Appl. No. 10/604,855
Amdt. dated December 13, 2004
Reply to Office action of October 21, 2004

REMARKS/ARGUMENTS

Fig. 3

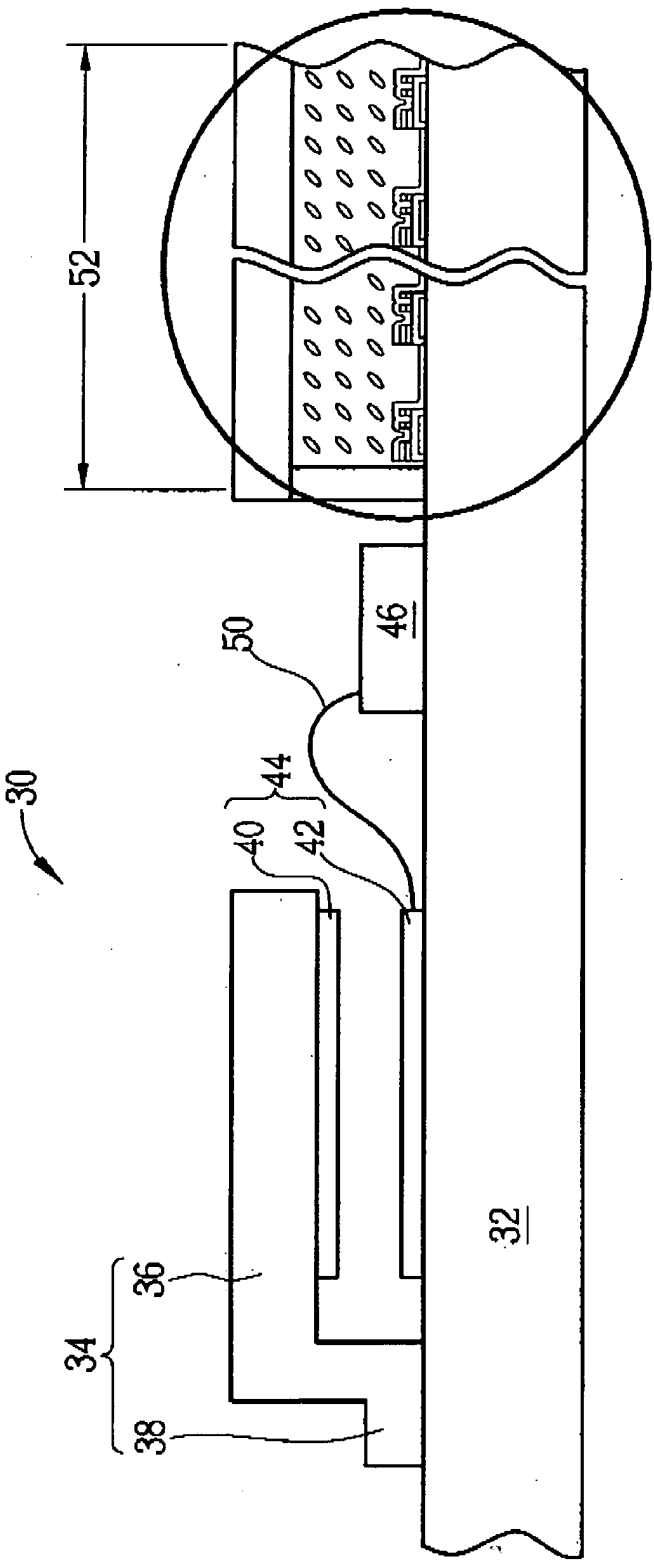
1. Objection to the drawings:

Fig.3 has been redrawn to clearly illustrate the TFT display area 52, as shown in the encircled area of the attached "Annotated drawing sheet". No
10 new matter is introduced by the above amendments, since it is in accordance with the originally disclosed TFT display area. Consideration of the proposed amendment to the drawings is politely requested.
